## **Bike Winnipeg Submission – Infrastructure Renewals and Public Works Committee**

### **Approval of the 2021 Edition of the Manual of Temporary Traffic Control on City Streets**

#### **Facilitating Turns on Bike Lane Detours**

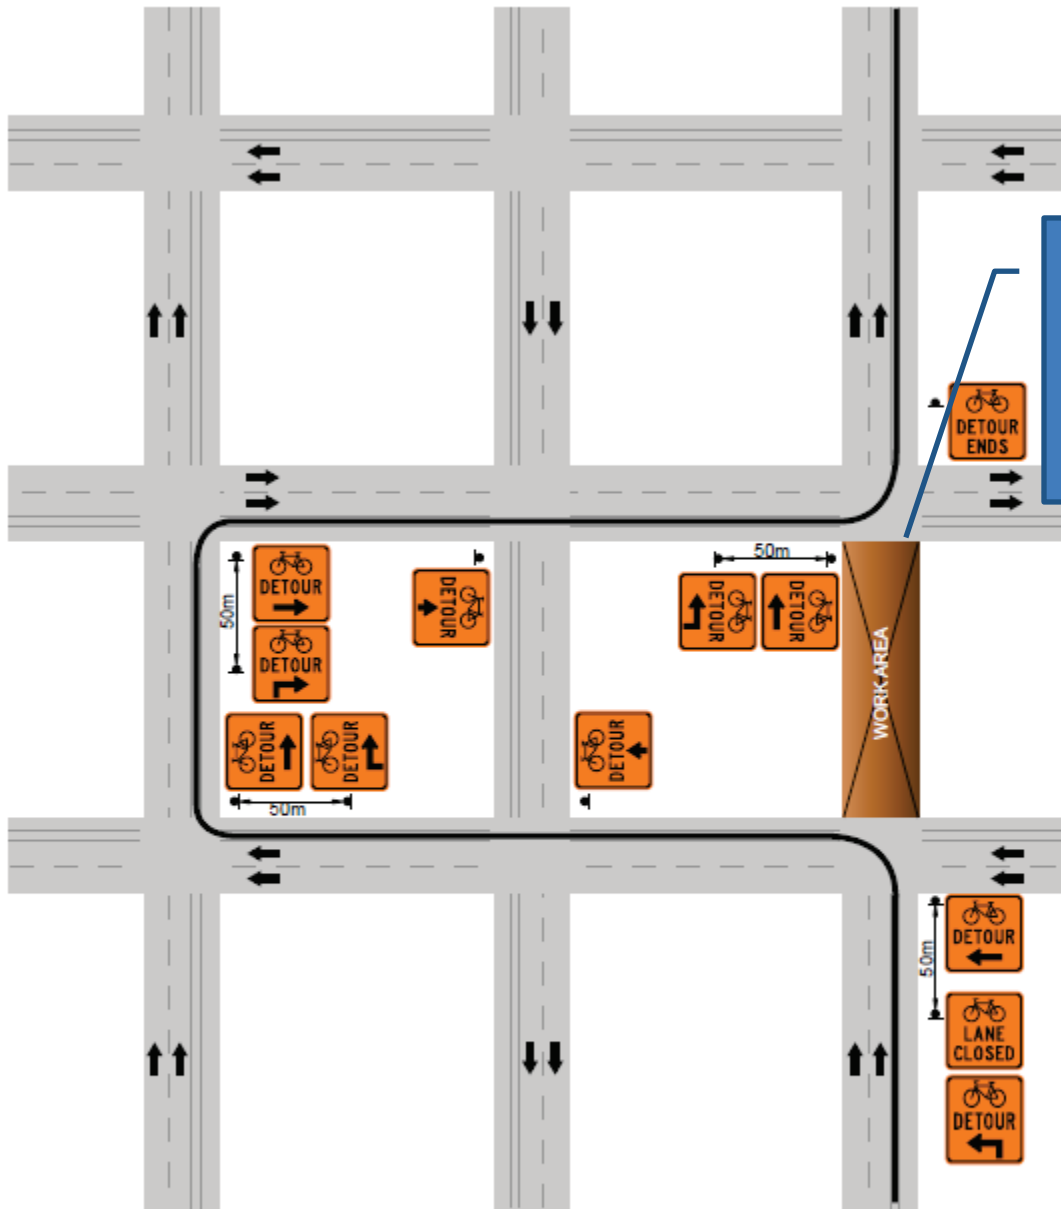
We’re happy to see the recommendations to include detours for bike routes whenever road closures are required, but recommend that requirements for the provision of two-stage left turn queue boxes be included in the manual along with recommendations on detour signage. Two stage turn queues allow people on bike to navigate a left turn across multi-lane streets (as shown in the example diagram from the manual below) in a safe, two-step process rather than forcing the cyclist to merge across traffic lanes.

To improve safety and comfort, we'd like to see provision for two-stage turn queue's included in the design manual
